IN THE DRAWINGS:

REMARKS

This Amendment is submitted in response to the Final Rejection dated March 14, 2006. In the Office Action, the Patent Office requires Applicant to provide information under 37 CFR §1.105 which the Patent Office has determined is reasonably necessary to the examination of the application. Additionally, the Patent Office refused to consider an Information Disclosure Statement (hereinafter "the IDS") filed on January 3, 2006 and asserts that the IDS fails to comply with 37 CFR 1.98(a)(2). Further, the Patent Office objected to the drawings under 37 CFR §1.84(p)(5) because the drawings include a reference character not mentioned in the description. Still further, the Patent Office objected to the drawings under 37 CFR §1.83(a) for failing to show every feature of the invention specified in the claims.

FIG. 8

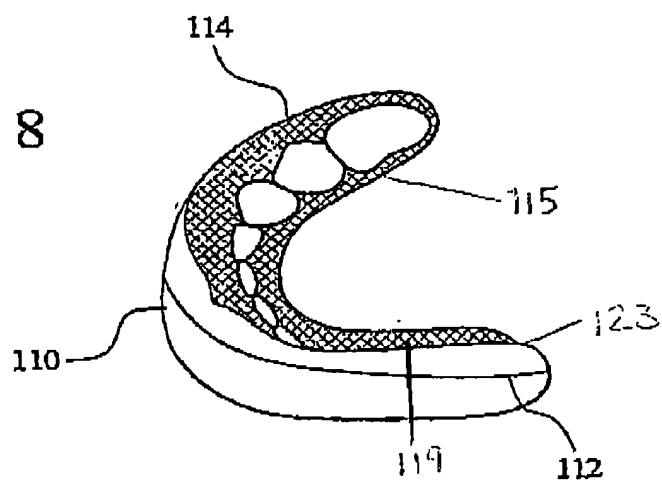
FIG. 8 has been corrected as shown in the Replacement Drawing Sheet and as shown in red in the Annotated Sheet Showing Changes in the attached Appendix.

Further, the Patent Office objected to the drawings under 37 CFR §1.84(p)(5) for failing to include reference signs 115, 117, 119 and 121 which are mentioned in the description. In response to the objection, Applicant amended FIGS. 8 and 9 to show the lingual shields 115, 117 and the buccal shields 119, 121 as set forth on page 22 of the description. Applicant also amended FIGS. 8 and 9 to show the rear portion 123 of the upper shell 110 and the rear portion of the lower shell 120.

The lingual shields 115, 117, the buccal shields 119, 121 and rear portions 123, 125 are disclosed in the specification as filed. Specifically, page 22, lines 2-5 state: "The upper shell 110 and/or the lower shell 120 may have roughened, or coarse surfaces 114, 122, respectively, along the lingual shields 115, 117 and/or buccal shields 119, 121 to secure the reline material 132." Further, page 22, lines 8-10 state: "The lingual shields 115, 117 and the buccal shields 119, 121 may have a mark 112 placed on the roughened surfaces 114, 122." Moreover, page 22, line 35 through page 23, line 2 state: "A rear portion 123, 125 of the upper shell 110 and/or the lower shell 120 may then be forcibly pushed down on the teeth." Applicant submits that the amendment to FIGS. 8 and 9
